WHARFE BRIDGE, BOSTON SPA

## BOSTON SPA PARISH COUNCIL

### **17/07970/OT NE Development Thorp Arch with implications for Boston Spa**

Project: **LAND OFF WALTON ROAD, THORP ARCH**  
 Title: **POTENTIAL BRIDGE ROAD IMPROVEMENT SCHEME**

# APPENDIX A

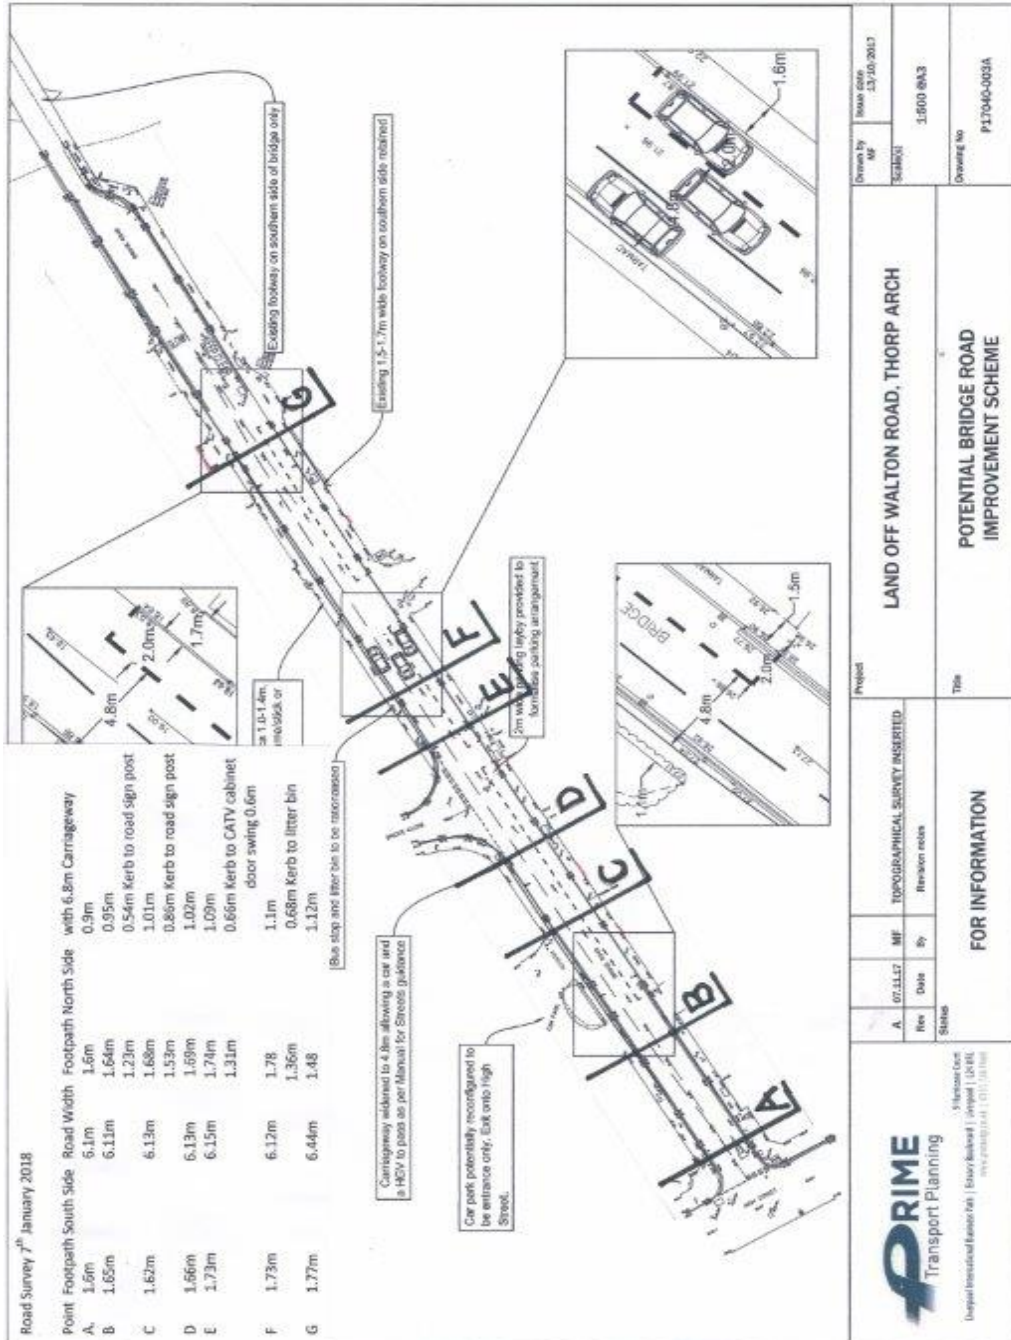
- 2.1 The following detailed examination should be read in conjunction with the map shown in Appendix A.
- 2.2 The intention to modify Bridge Road from Thorp Arch Bridge to the High Street by narrowing the walkway on the northern side is both impractical and dangerous. The length of road from the Boston Spa T-junction to the north of the bridge was demonstrated at the TATE public enquiry to act as one “complex”. This has not been possible to model, and so predictions of the effects of extra traffic are not possible. It is already clear that the “complex” is overloaded.

- 2.3 We have measured the walkway and the results are provided on an annotated version of the developers map.
  - Cross sectional points show that the walkway, once narrowed to accommodate the road width required, would range from as little as 0.9m at point A to 1.09m at point E. This is well below the standard required.

- At section A the walkway width of 0.9m is also at the drop kerb crossing point for disabled pedestrians. There would not be sufficient room between the drop point and the wall to manoeuvre a wheelchair or a buggy and parent trying to cross the road. Indeed, larger vehicles regularly mount the kerb when turning left from High Street into Bridge Road further adding to the risk for pedestrians. Buses at this point require the full width of the road to make the turn. A reduction in the walkway at this point clearly creates an unacceptable health and safety risk.

- At points between A and E vehicles regularly mount the pavement to create space for passing whilst standing traffic waits on the uphill section. Again, to encourage this manoeuvre with a small amount of added road space will further entice motorists to continue this dangerous practice.

- At point E the placement of the CATV cabinet will reduce the walkway width to 0.6m and the cabinet door swing is 0.6m - an impossible width for pedestrians with buggies, children, wheelchairs, mobility scooters, etc.

- The bus stop between points E and F presents further safety issues. A narrower walkway at this point increases the risk for those queuing for a bus. The data provided in Appendix 1 of the Bridge Road Survey Data is clearly untrue as on every school day up to a dozen school children wait at the bus stop for the school bus and these numbers are apparently not recorded. The position of the cameras could be giving false data at this point. The siting of cameras does not capture the use of pathways at the junction where both the north and south walkways have much greater use at the crossing and for people going to the car park using Bridge Road.

- Below point G driveway access to Dovecote House, Dovecote Cottage and Littlecroft Cottages is already difficult when exiting right up the hill. Sight lines are only just adequate and require

cars to protrude onto the full width of the pavement to see traffic coming down the hill. A narrowing of the walkway will mean cars having to stick out into the carriageway to view the advancing downhill traffic. Indeed, sight lines from all roads and driveways on the north side will be reduced by a narrowing of the walkway.

- The width of the proposed parking bays at 2m on the south side is inadequate. The width of residents' cars parked there has been measured at 1.985m with wing mirrors retracted and 2.090m including wing mirrors. Clearly tolerances either side are inadequate.

- HGV's such as refuse collection lorries and buses cannot pass side by side in the 4.8m width proposed. A modern bus fleet is designed with a width of 3.1m which includes 230mm extrusion of rear view mirrors on both sides of the bus. Further, the danger to pedestrians of a strike from such mirrors is increased on a narrow pathway.

- The walkway on the southern side is already less than the standard required and overall no part of the walkways on either side meets current regulations so a further reduction is unacceptable.

2.4 The proposal to have all car park vehicles exiting onto the High Street is flawed and dangerous. Exiting at this point to the left would be directly into the controlled pedestrian crossing and any standing traffic would invariably cause pedestrians and cars to compete for the same pathway space. Turning right would require manoeuvres through standing traffic with consequent reduced sight lines in what can be a very congested area.
